Docket No. 08-AFC-8

Association of Irrigated Residents
Preliminary Comments on the PSA, part 1 for HECA
Docket #08-AFC-8
September 30, 2010

HYDROGEN ENERGY CALIFORNIA PROJECT

Preliminary Staff Assessment, Part I

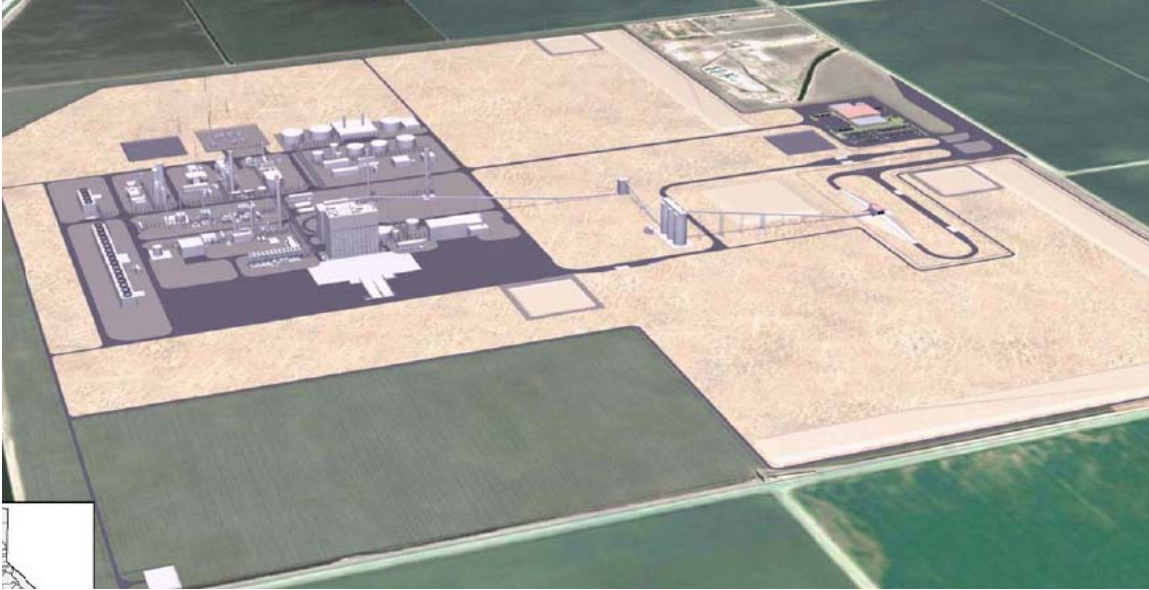
Brackish water is a relative term and slightly brackish water can still be used for irrigation of certain crops, especially if it is mixed with a source of fresher water. A determination needs to be made of the average TDS of this water and the projected TDS in future years as water is removed from the underground area. At a stated level of TDS, HECA has to guarantee they will no longer use that water for their wasteful cooling needs.
